**II. Amendments to the Drawings**

### III. Remarks

Fig. 3C

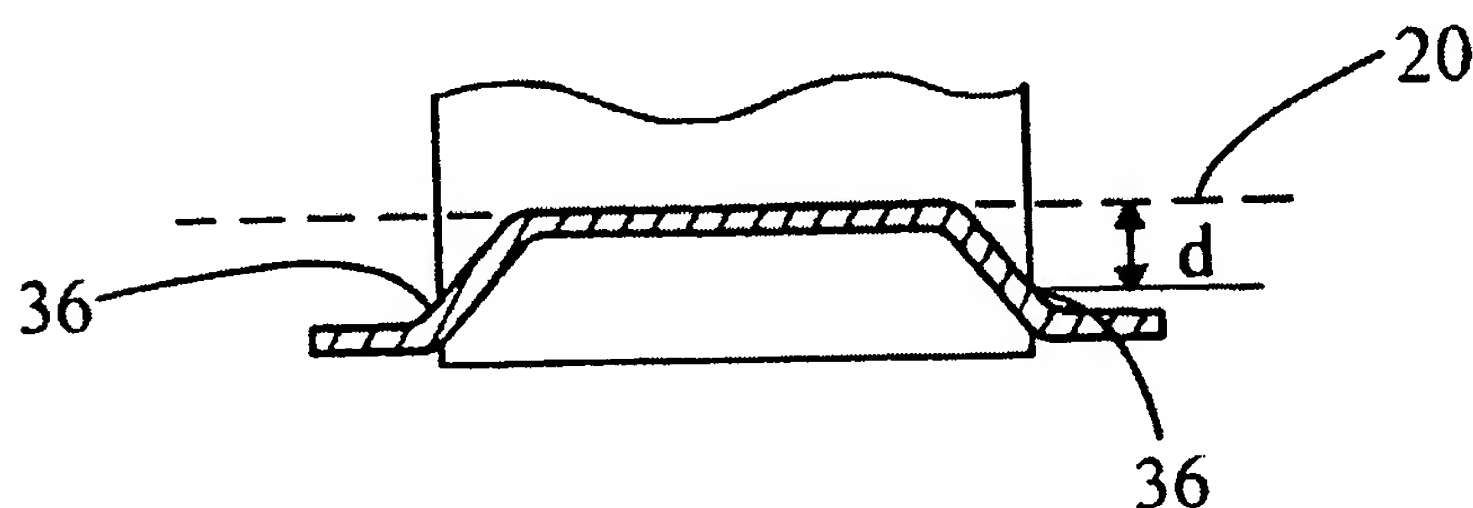
Examiner has stated that the specification as originally filed lacks an adequate written description of the invention. Examiner has further stated that "[t]here is no basis for the recitation 'an angle between about 15 and 75 degrees' in set forth in claim 1." Applicant respectfully traverses this rejection.

Figure 3C shows a separation distance (d) between the terminal ends 62 of the end sections 58 and the plane of the planar portion 56 (See Figure 5 and paragraph [0025]). Paragraph [0025] states, in the second-to-last sentence, that the separation distance (d) may be in the range from about 2 mm to about 20 mm. Paragraph [0026] states that the end sections 58 are about 2.5 mm to 28 mm long. As shown above, part of the dashed line showing the line of deformation 20 can be combined with the distance (d) and the end section 58 of the slot 52 to form a right triangle. Claim 1 states that each step portion extends laterally at an angle between about 15 and 75 degrees from the plane of the base portion. This angle is the angle opposite distance (d) in Figure 3C (shown above). The sine of an angle is equal to the length of the opposite side divided by the length of the hypotenuse. Therefore, the sine of the angle of Claim 1 [hereinafter  $\alpha$ ] is the distance (d) divided by the length of the end section 58:

$$\sin \alpha = \frac{(d)}{length_{end-section}}$$

The originally filed specification gives dimension ranges for (d) and dimension ranges for the length of the end section 58, which can be substituted into the above equation:

$$\sin \alpha = \frac{2 - 20mm}{2.5 - 28mm}$$

Solving for the above equation, the range of the angle  $\alpha$  is about 4.1 degrees to about 89.9 degrees. Therefore, the range of the angle of Claim 1 (15 to 75 degrees) is well within the range that a person having ordinary skill in the art would be taught from the specification as originally filed.
